## UTAH OIL AND GAS CONSERVATION COMMISSION

| WELL NO             | UPPER SANDWASH #2-20A3            |                     |                  | API NO. 43-013-31483 |             |                |                 |

**APPLICATION FOR PERMIT TO DRILL, DEEPEN, OR PLUG BACK**

DRILLING LOCATION ASSESSMENT

**FIGURE #1**

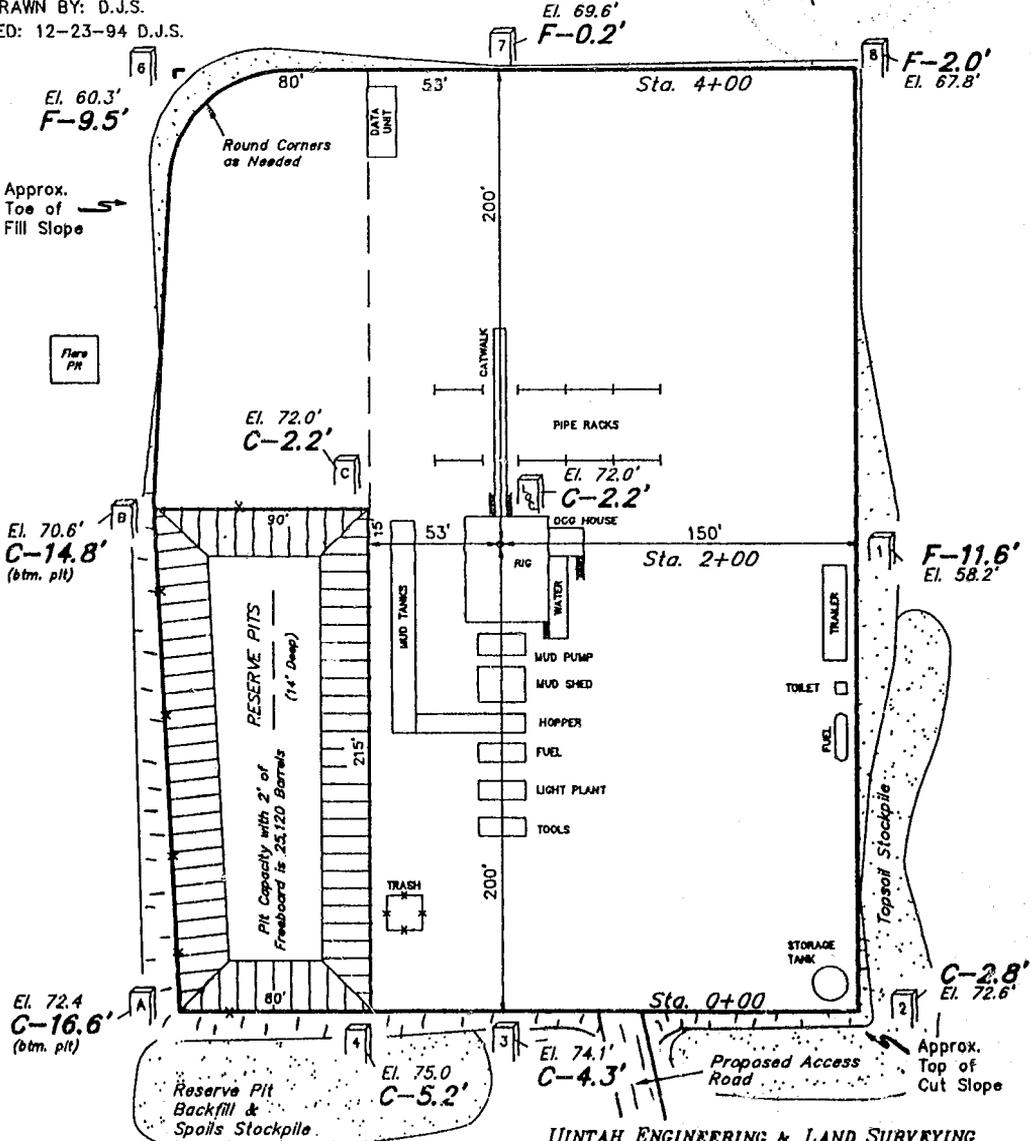
The operator has shortened the width of the reserve pit from 120 feet to 80 feet, at the request of the State. Please see Figure 1, attached, and consider these diagrams as the correct ones to be attached to the Application for Permit to Drill for the above described well.

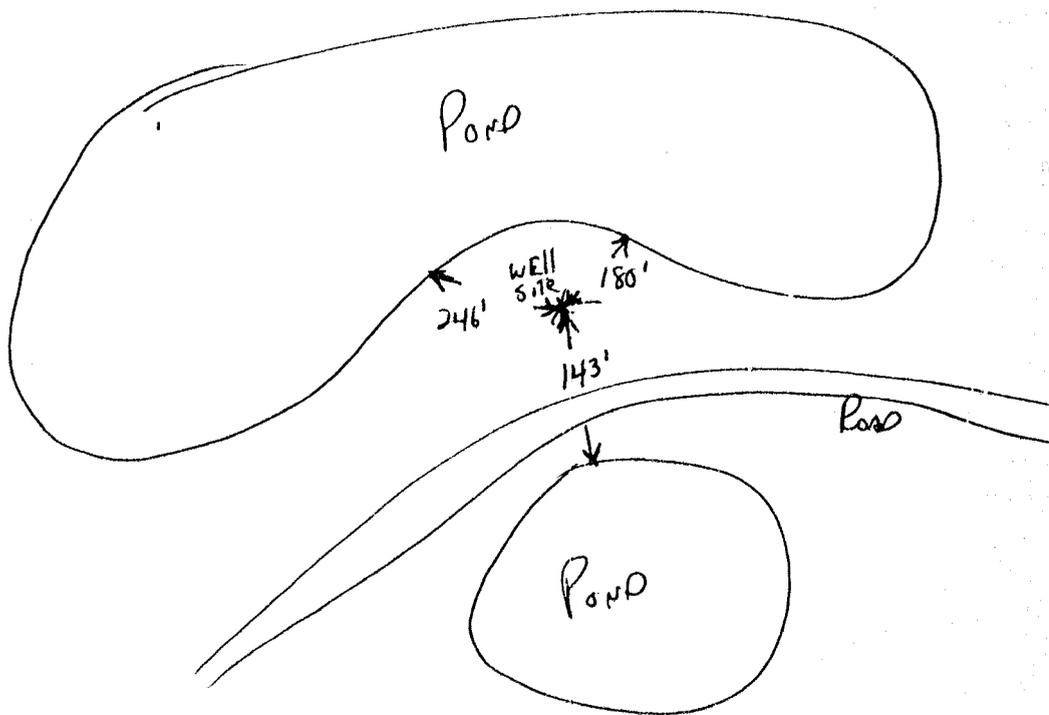
| GENERAL   | Inspected (✓) |
|---|---------------|
| Remarks: <u>SEE DRAWING TO SHOW APPROX FOOTAGE TO WATER IN THREE DIRECTIONS, FROM PROPOSED WELL.</u>  |               |

12:00 Noon<sup>o</sup> Drove to & INSPECT PROPOSED  
WELL BECAUSE OF LANDOWNER COMPLAINT<sup>o</sup>  
WELL NAME<sup>o</sup> UPPER SANDWASH #2-20A3  
SEC 20; T1S; R3W  
Disc. 1900 FSL; 1850 FWL
